Informal document **GRPE-85-38**  
85<sup>th</sup> GRPE meeting, January 2022  
Agenda Item 8(b)

**Proposal for amendments to GRPE/2022/6  
(draft GTR2 Amendment 5)**

Proposals for amendments to draft GTR2 Amendment 5 (GRPE/2022/6) are marked in track changes. This is the consolidated version.

Figure A1/5  
Particulate sampling system

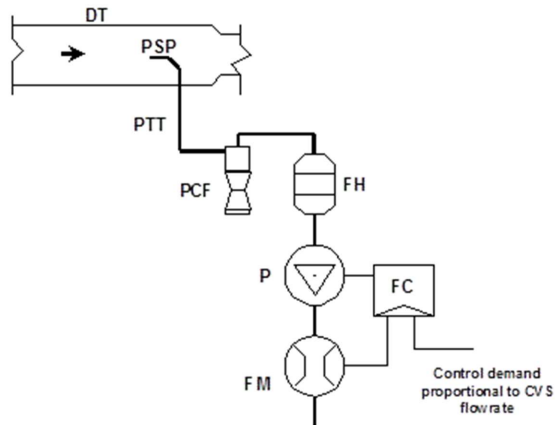
Commented [EPPR2]: Editorial correction of formula
